Second Request for Additional Information
Holtec International
Docket No. 71-9375
HI-STAR ATB 1T Package

By letter dated February 6, 2017, Holtec International (Holtec) submitted an application for Certificate of Compliance No. 9375, Revision No. 0, for the Model No. HI-STAR ATB 1T package. By letter dated April 14, 2017, Holtec responded to a request for supplemental information (RSI) letter dated March 21, 2017. The application was accepted for review on May 10, 2017. By letter dated December 8, 2017, Holtec partially responded to the first request for additional information (RAI) letter dated August 9, 2017, and completed its responses by letter dated April 2, 2018.

This second request for additional information (RAI) identifies information needed by the U.S. Nuclear Regulatory Commission staff (the staff) in connection with its review of the HI-STAR ATB 1T package application to confirm whether the applicant has demonstrated compliance with regulatory requirements.

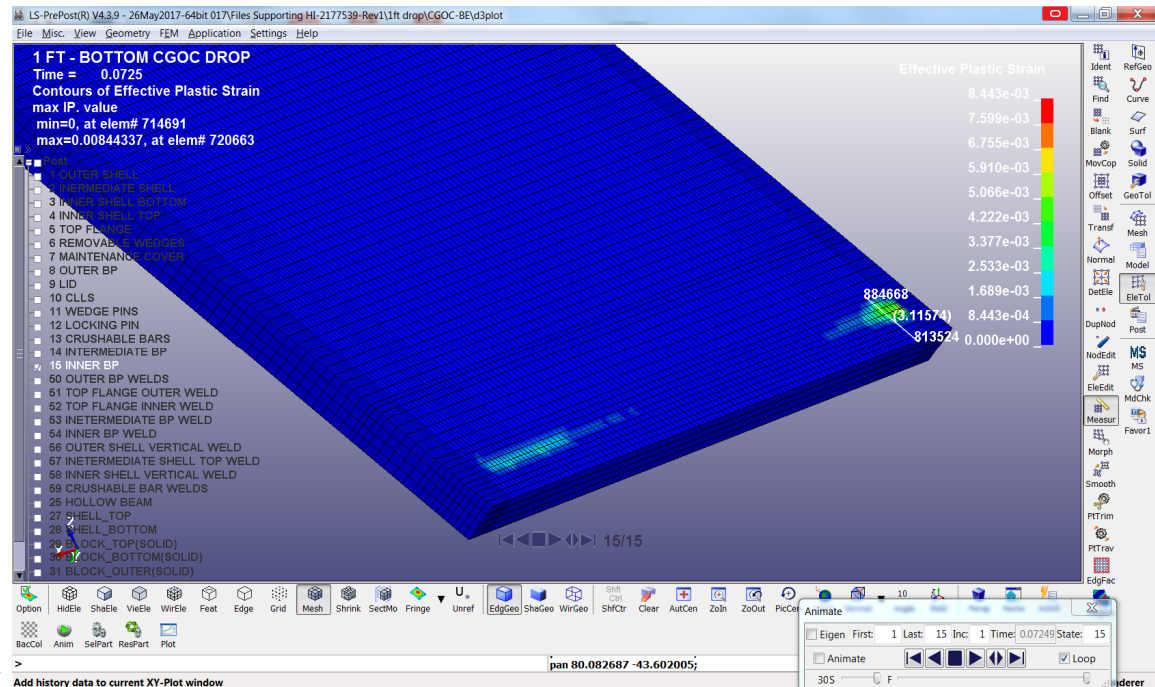
2-1 Clarify how the components in the containment boundary will not exceed ASME Section III NB values for normal conditions of transport (NCT).

RAI 2-14, dated August 9, 2017, requested the applicant to confirm that stress limits within the lid of the ATB 1T package do not exceed the values set forth by ASME for the 1-ft bottom end drop simulation for NCT conditions. However, the LS-DYNA simulations show that the inner base plate (and other components that are also part of the

containment boundary) also undergo plastic deformation, as shown in the Figure below for the 1-ft NCT Bottom CG over corner drop. Specifically, there is inelastic strain 3 inches away from the edge of the part on the surface.

Since inelastic deformations indicate that ASME stress levels are exceeded, the applicant shall (i) reconfirm that all containment boundary components do not exceed stress intensity values, according to ASME Section III NB, for all NCT drop and penetration simulations, and (ii) update tables and calculations in the application, as necessary.

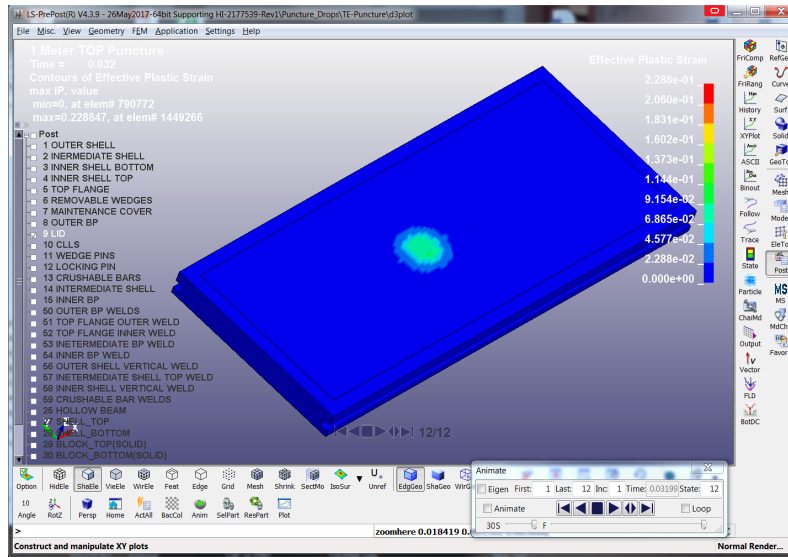
- 2-5 Clarify the effective plastic strain reported for the top end puncture simulation.

Table 8.3 of the report, "Drop Analysis of the HI-STAR ATB 1T Transport Package" indicates that the maximum strain in the lid is 14.13%. However, from the files submitted, the maximum effective plastic strain is reported to be as high as 22.9%, as shown below on staff's plot using the applicant's model.

Verify this value, and others like this one in similar tables of this report, ensure all values in the application match the values in the models, and update the tables as necessary.

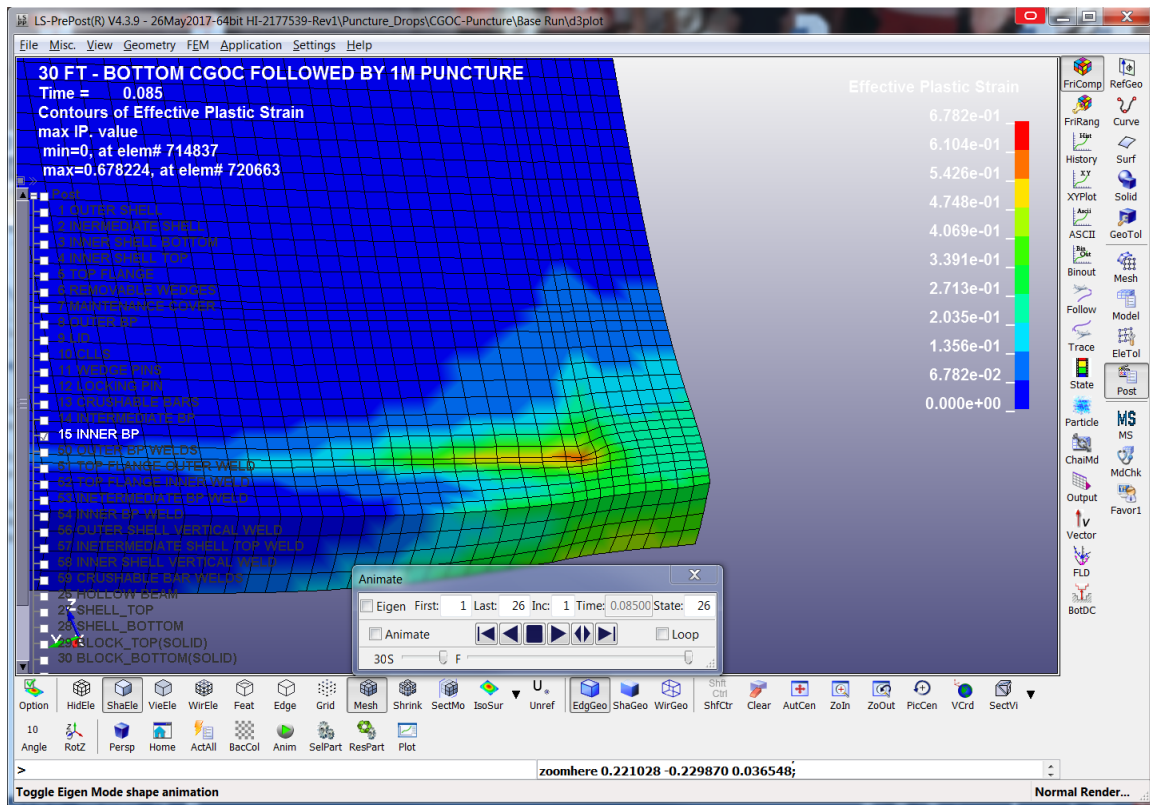
- 2-6 Clarify the effective plastic strain reported for the containment base plate and containment weld for the CG over corner followed by puncture simulation for hypothetical accident conditions (HAC).

The applicant indicates there is an effective plastic strain of 40% for the containment base plate (BOM 1) and of 35% for the adjoining containment weld. However, from the files submitted, the maximum effective plastic strain is reported to be as high as 67.8% for the containment base plate and 57.1% for the adjoining containment weld, respectively. Table 2.4 shows the allowables for the material which are exceeded in this case. Both of these effective plastic strain values exceed the values tabulated in Table 8.3 of the application.

Verify that these values are correct and revise the application, and any supporting calculations, as necessary. Note that all simulations should be re-examined and the application updated, as necessary.

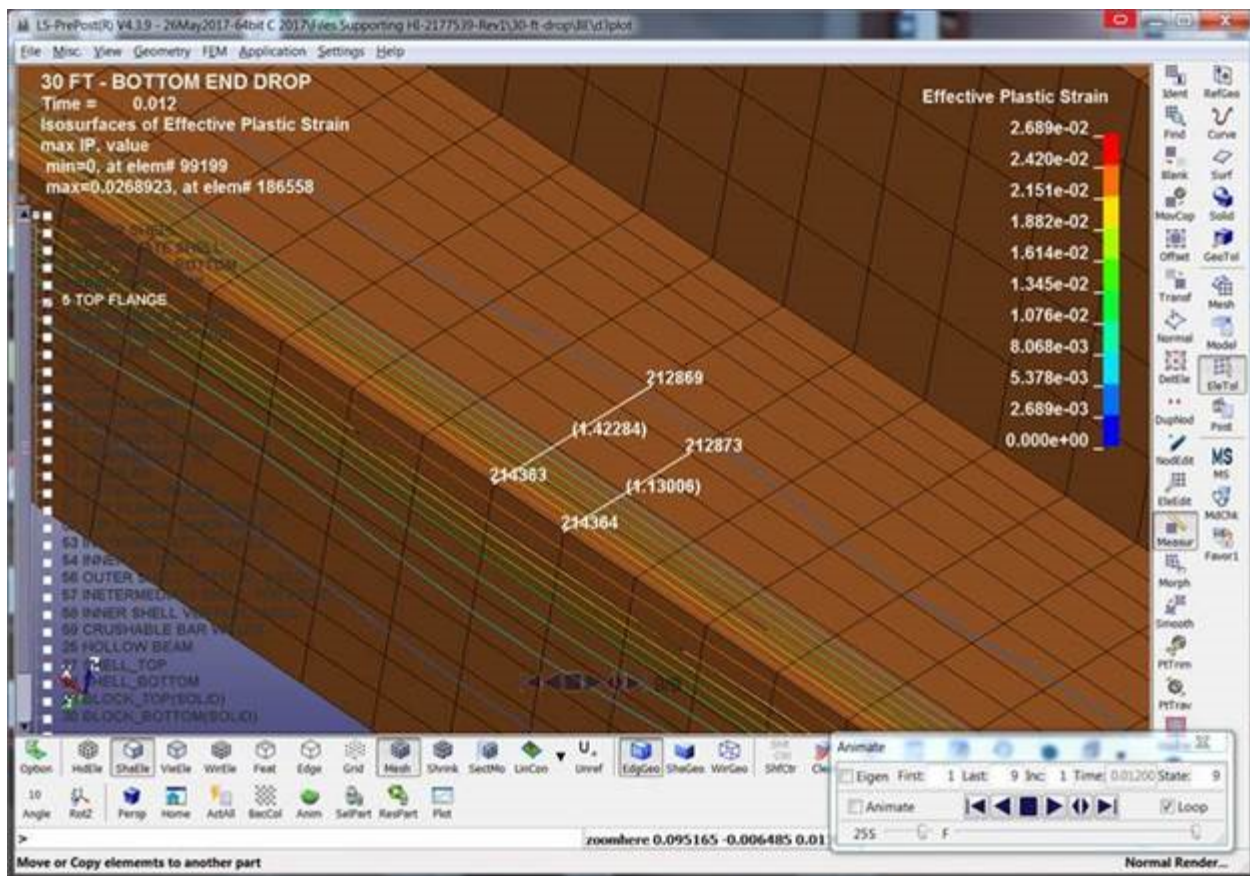
- 4-1 Provide evidence that demonstrates the package will meet regulatory release limits during normal conditions and hypothetical accident conditions.

The responses to RAI 2-13 and RAI 4-1 indicate that plastic deformation occurs at the seal and closure region during normal conditions of transport and hypothetical accident conditions. Plastic deformation at the seal and closure region after the 30 ft drop is further shown in the LS-DYNA plot below (seal region of the top flange). However, there was no demonstration that a resulting leakage rate from the package would ensure there would be no loss or dispersal of radioactive contents limited to that described in 71.51(a).

It is also noted that the seal's spring back would not necessarily be sufficient to ensure containment.

Figure 5-3-1: HAC Model of ATB-1T with Rotated BTC bottom plate

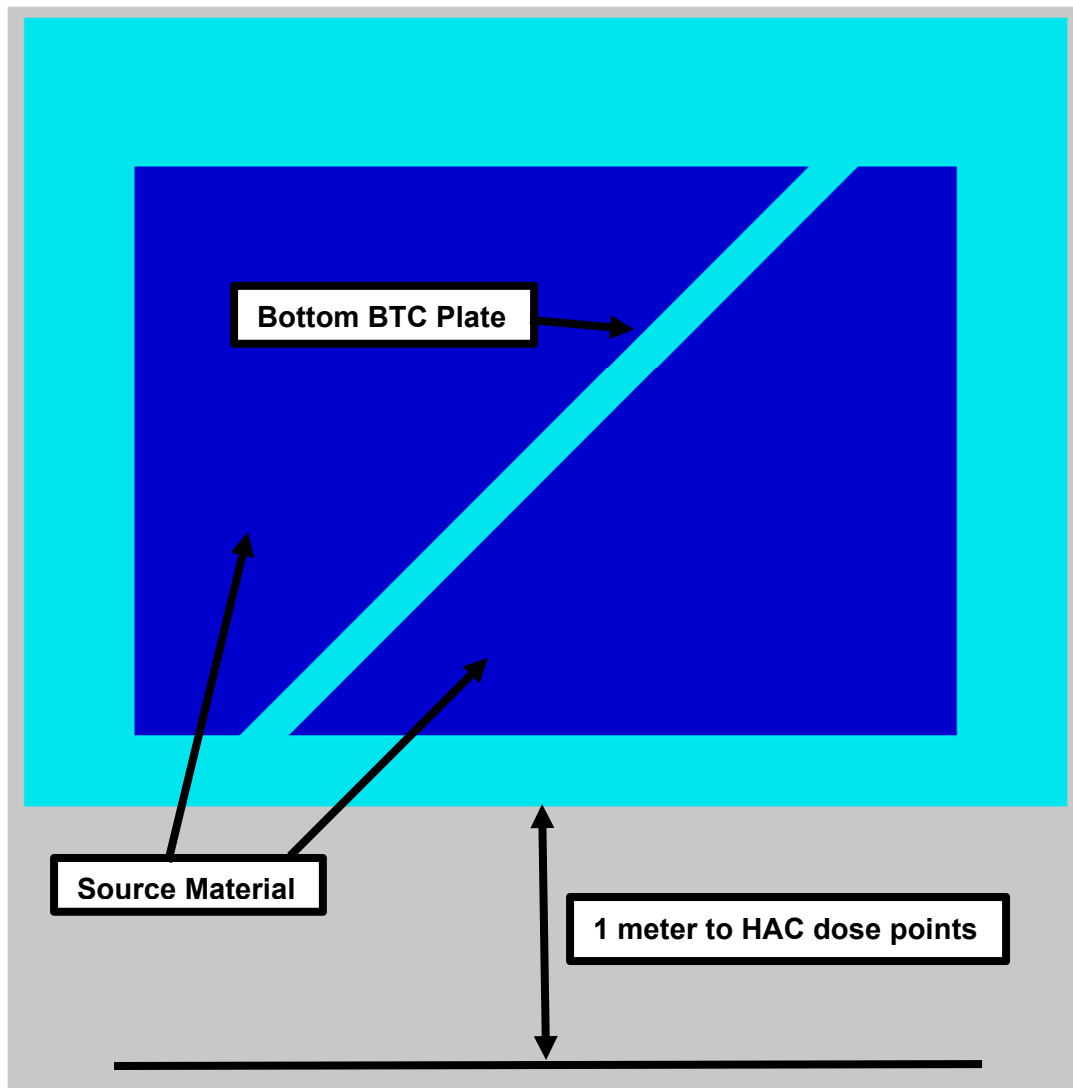
- 5-3 Evaluate HAC dose rates using a bounding model of the bottom BTC (BFA-Tank Cassette) plate or restrict contents so that the source cannot relocate outside the BTC plates.

The staff performed a confirmatory evaluation and compared the dose rates with a similar modeling assumption of the bottom BTC plate as done in the application (i.e. in the same location but partially removed) and compared it to a model with the BTC plate rotated by 45 degrees. The staff found that the BTC plate rotated by 45 degrees would result in a significant increase in HAC dose rates that exceed the limit in 10 CFR 71.51(a)(2). The staff’s model assumed that the contents with maximum specific activity relocated to the other side of the plate (see Figure 5-3-1 below).

- Restrict the contents so that it cannot relocate to the other side of the BTC plates under HAC, or
- Calculate external dose rates under HAC for contents with consideration of the potential content relocation assuming bounding configuration for the bottom BTC plate and justify the modeling assumptions are bounding.
